**To:** The Design Advisory Board  
**From:** Mary O'Neil, AICP, Senior Planner *moreil*  
**RE:** ZP 14-1300CA/CU 85 Lakeview Terrace  
**Date:** July 8, 2014

**Request:** Construction of a 2 story addition to existing single family home; remove existing shed and construct new accessory structure for accessory dwelling unit and storage.

Existing Site Plan

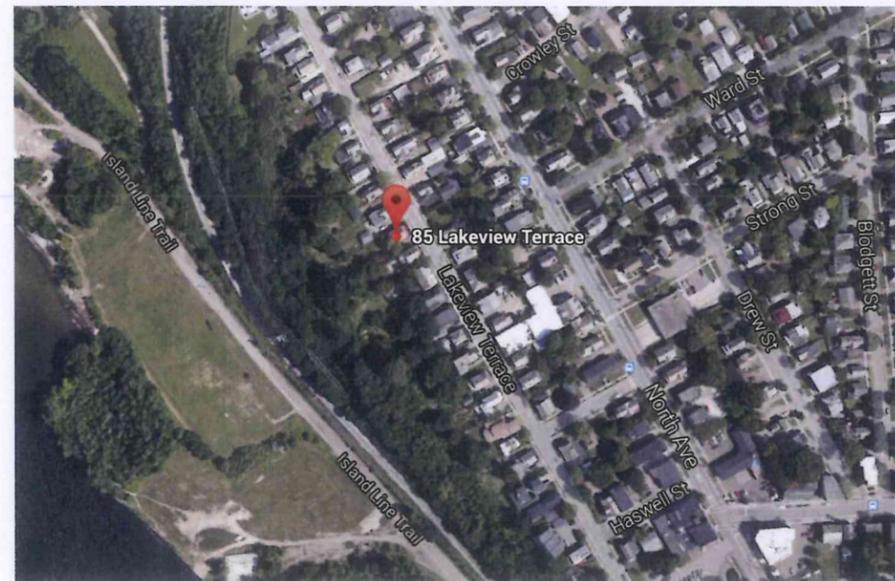
The proposed site plan illustrates a walkway from the parking area/drive to the accessory dwelling (walkways are permitted to encroach within setbacks.) There is no walkway to the primary residence from either the sidewalk or from the drive to the house. Some method of pedestrian connection will need to be illustrated for the primary residence.

The single family home requires 2 parking spaces, and the proposed accessory dwelling unit 1 parking space (Per Zoning Ordinance Amendment 13-10). Three parking spaces are illustrated on the site plan; outside the front yard setback, 2 in tandem to serve the primary residence. The existing curbcut will be utilized.

A planting box is illustrated at the foot of the stairs on modeling studies, and three unidentified trees on the site plan. No formal landscaping plan has been submitted, and further planning in that regard will be a requirement prior to review by the DRB.

1. An EPSC plan shall be approved by the City Stormwater Engineer **prior to release of any zoning permit.**
2. A pedestrian walkway shall be included between the public sidewalk and the primary residence, and/or between the parking area and the primary residence. A coverage re-calculation will be required for this addition/revision.

East/West  
Elevations

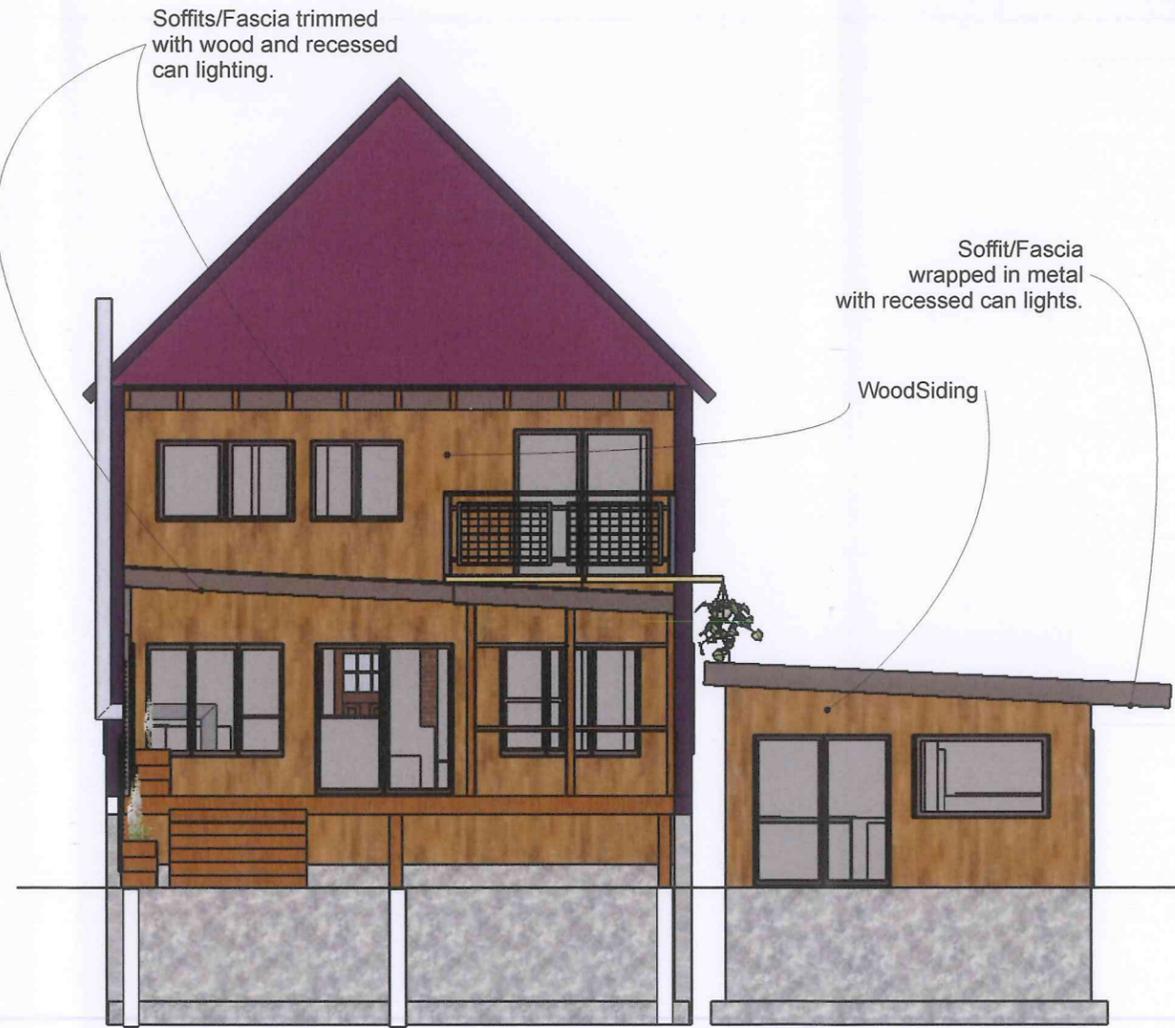
Window openings for the new rear addition are regularly placed, mimicking the placement, arrangement and size of windows in the primary residence. The westerly elevation clearly and understandably intends to exploit the incredible lake views.

Guest Cabin Floor Plan

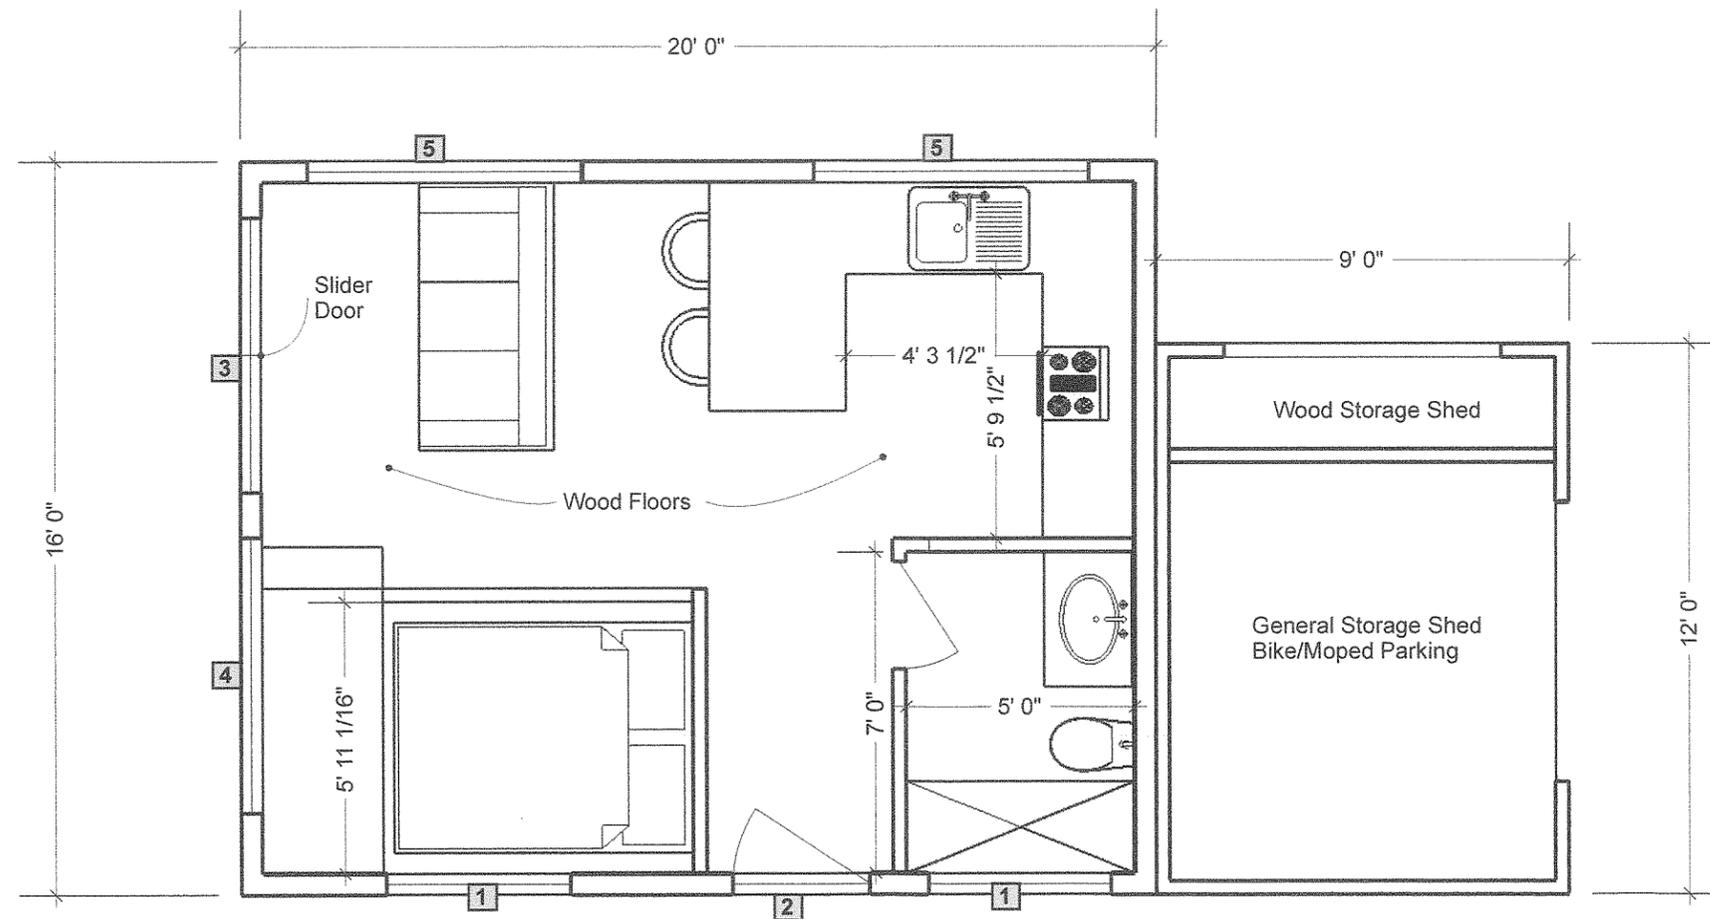
Windows and doors on the accessory structure are limited in size and number; with the largest facing west. It remains odd that the primary entrance for the ADU is facing the southerly property line (remote, and close to the property boundary), with small windows that will prohibit passive solar gain on the southerly exposure. A reassessment of this arrangement is recommended to

relocate the entrance to the east or north, with greater window glazing on the south.

It is again encouraged to move the primary entrance of the ADU off the south elevation near the property boundary toward the interior of the lot.

3. It is recommended that the primary entrance to the accessory dwelling unit be relocated from the south elevation to either the east or north to direct resident traffic toward the interior of the lot rather than against a property line. It is further suggested that a primary window would be welcome on the streetfront/east façade, as would a window to capture easterly light into the accessory dwelling unit. “Flipping” the project plan would accomplish locating the entrance on the interior, and providing a greater amount of glazing on the south elevation, increasing solar gain.
